Well Name: SAKER 6-7 FEDERAL COM	Well Location: T24S / R35E / SEC 6 / LOT 3 / 32.253263 / -103.409794	County or Parish/State: LEA / NM
Well Number: 3H	Type of Well: OIL WELL	Allottee or Tribe Name:
Lease Number: NMNM014164	Unit or CA Name:	Unit or CA Number:
US Well Number: 3002549456	Operator: OXY USA INCORPORATED

Notice of Intent

Type of Submission: Notice of Intent	Type of Action: APD Change
Date Sundry Submitted: 04/14/2025	Time Sundry Submitted: 02:23
Date proposed operation will begin: 06/15/2025

**Procedure Description:** OXY USA Inc., respectfully requests to amend the subject AAPD to revise the SHL,BHL, TVD and Drill Plan. Old SHL: 200' FNL 1670' FWL New SHL: 200 FNL, 1570 FWL Old BHL: 20' FSL 2200' FWL New BHL: 20' FSL 1033' FWL Old TVD: 9204' New TVD: 11236' \*WELL NAME CHANGE SUNDRY SUBMITTD SEPARATEY, ACTION ID: 2846876 \*THERE IS NO ADDITIONAL SURFACE DISTURBANCE RELATED TO THIS SUNDRY" Attached is the updated C102, drill plan, directional and APD Change Worksheet.

Property Name SAKER 6_7 FED	Well Number 3H	Drawn By R.J. 12-20-19	Revised By REV: 2 L.T.T. 03-31-25 (SHL & WELLBORE CHANGES)
--------------------------------	-------------------	---------------------------	---

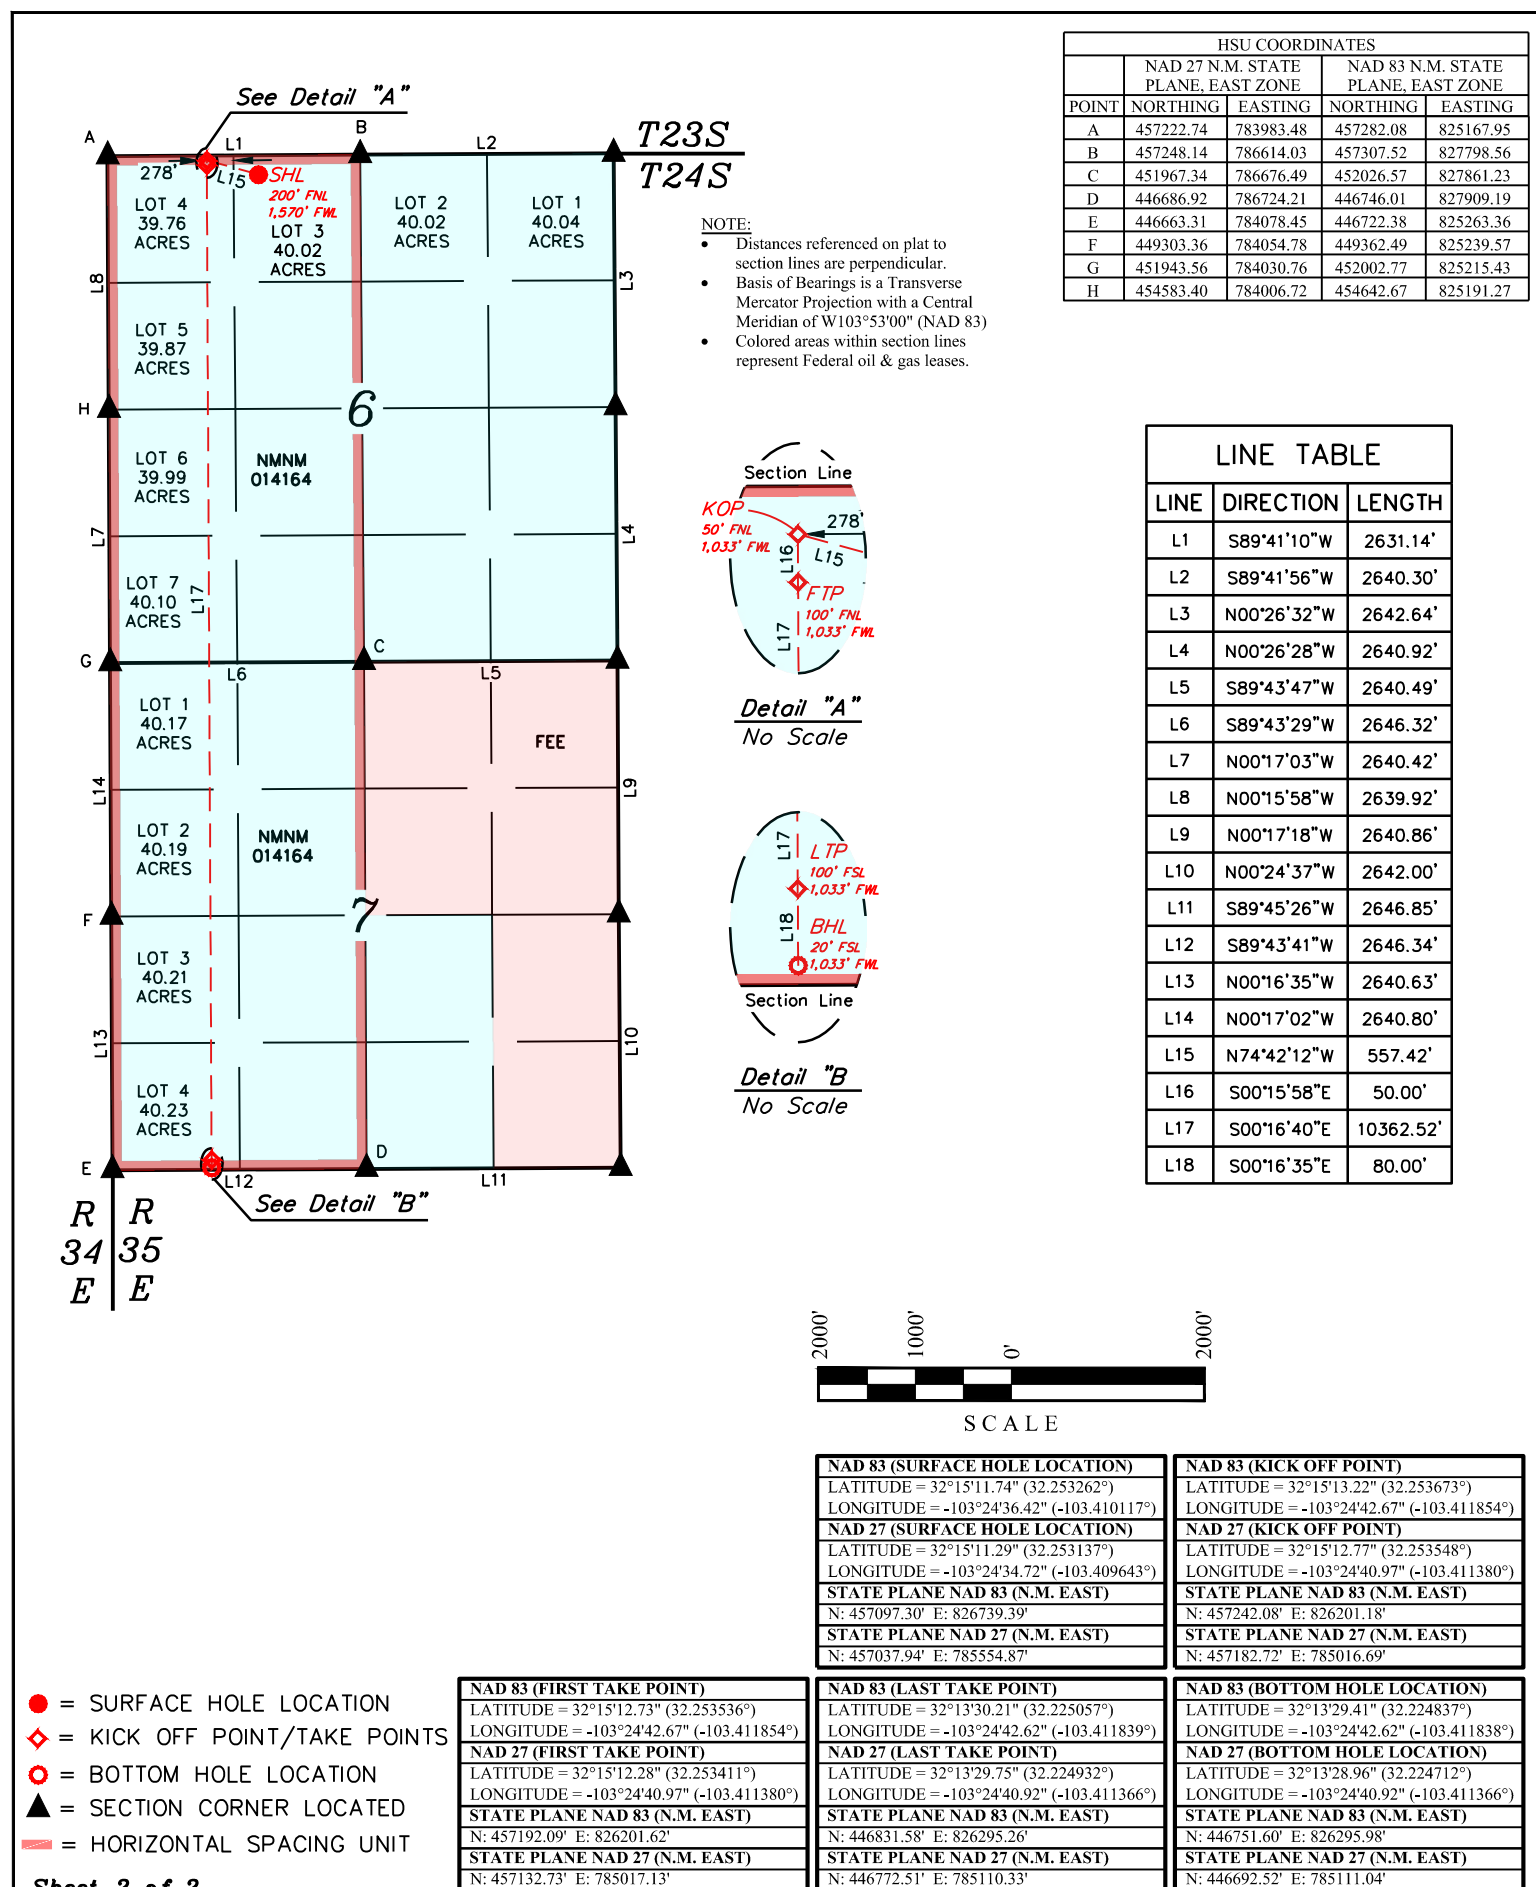
OXY USA Inc., respectfully requests to amend the subject AAPD to revise the SHL,BHL, TVD and Drill Plan.

Old SHL: 200' FNL 1670' FWL

New SHL: 200 FNL, 1570 FWL

Old BHL: 20' FSL 2200' FWL

New BHL: 20' FSL 1033' FWL

Old TVD: 9204'

New TVD: 11236'
